<b>Docket Number:</b>	12-AFC-03
<b>Project Title:</b>	Redondo Beach Energy Project
<b>TN #:</b>	205189
<b>Document Title:</b>	City of Redondo Beach Comments to South Coast Air Quality Management District Notice of Public Meeting for Proposed Modification
<b>Description:</b>	Public Meeting held on 06-25-15
<b>Filer:</b>	Jon Welner
<b>Organization:</b>	Jeffer Mangels Butler & Mitchell LLP
<b>Submitter Role:</b>	Intervenor Representative
<b>Submission Date:</b>	6/29/2015 8:21:29 PM
<b>Docketed Date:</b>	6/30/2015

Re: *City of Redondo Beach's Comments in Response to "Notice of Public Meeting for Proposed Modifications to AES Power Plant in Redondo Beach, CA"*

LAX 5-year Wind Rose

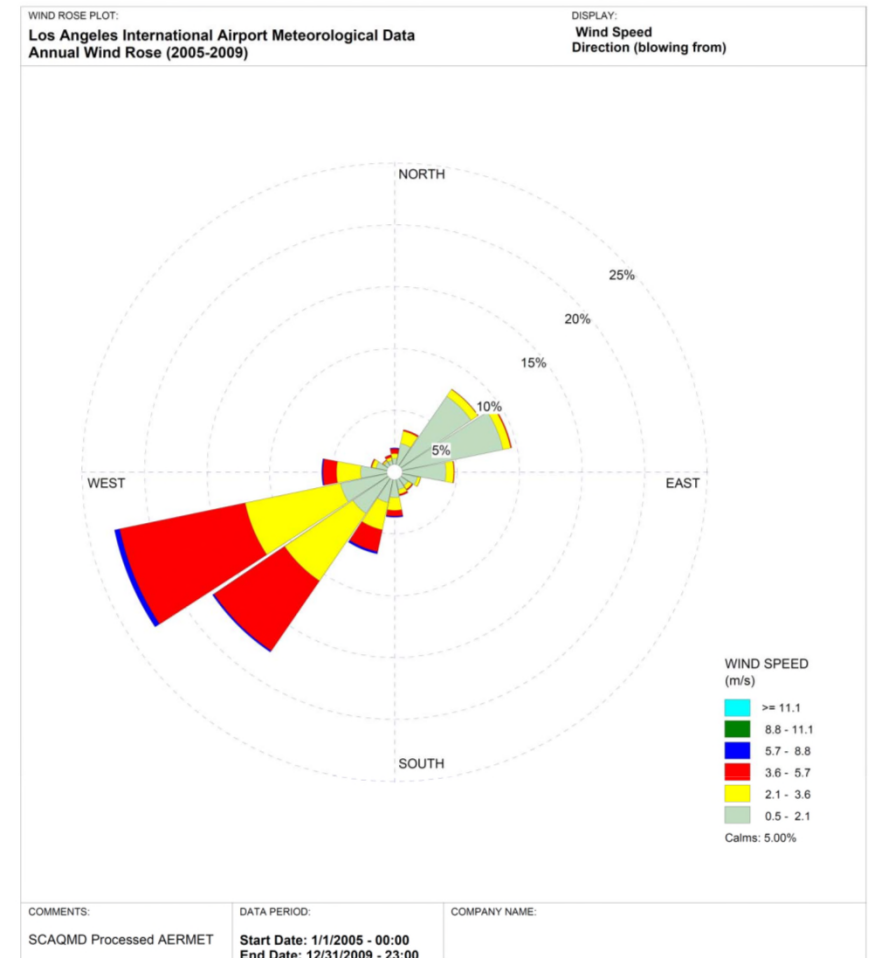
- AES' "standard" approach does not apply
- Unique, complicated scenario:
  - Shoreline location
  - Bluff to east; Palos Verdes peninsula
  - Lower power plant stacks
  - Atmospheric effects: Fumigation and Stagnation issues
  - Strong turbulent sea breezes
- Special impacts on nearby Bluff not studied
- Secondary fine PM formation not studied
- AERMOD and SCREEN3 models not acceptable for unique situation
- Edison decided against Redondo Power Plant repower in 1970s and 1980s

# Offshore Pollution Flow & Return

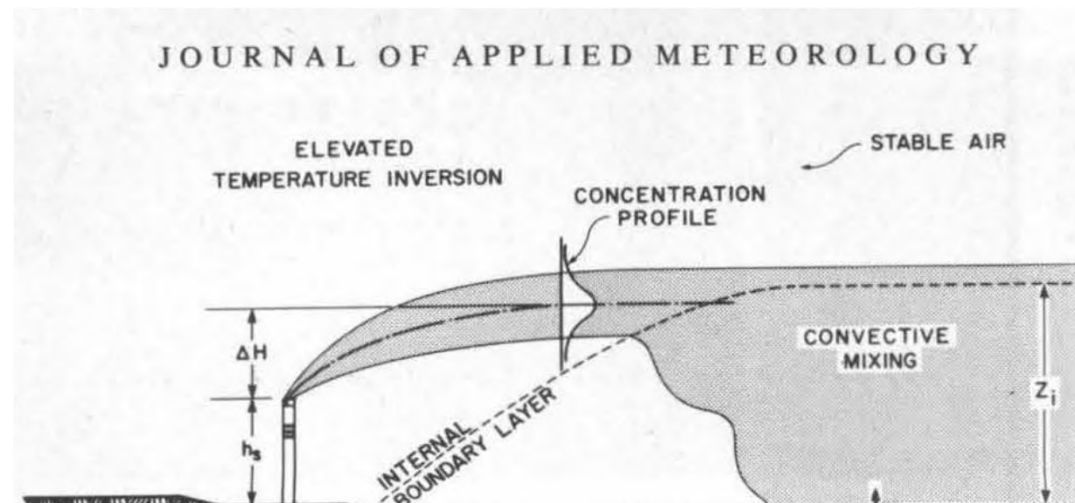
- Night: offshore pollution mixes to sea surface (fumigation) and may accumulate
- Day: Pollution may return to Redondo Beach
- Phenomenon not addressed by AES
- PM and air toxic impacts may be much greater than reported

# Onshore Fumigation and Stagnation

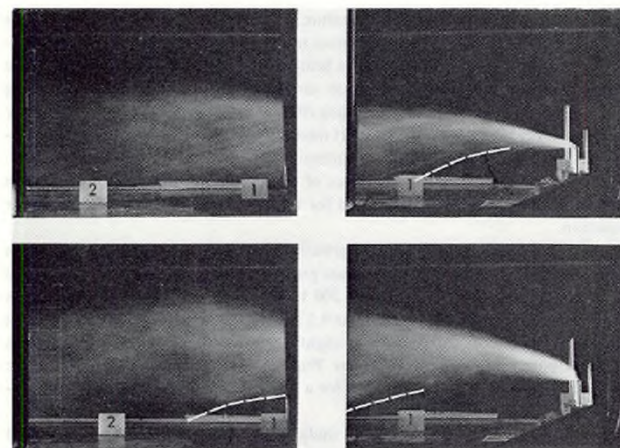
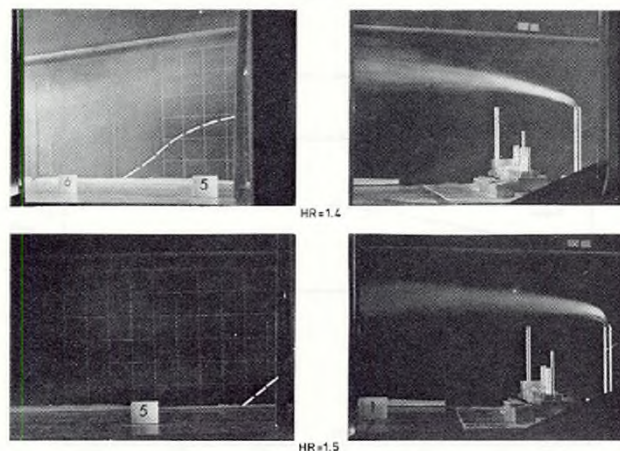
- Onshore fumigation study by AES not adequate
- PM not included
- SCREEN3 model a crude tool to address important impacts
- Stagnation events (low or calm winds) keep pollution in Redondo Beach
- 200-foot bluff one mile to east; 140-foot stacks
- Long-term PM and air toxic concentrations could be much higher
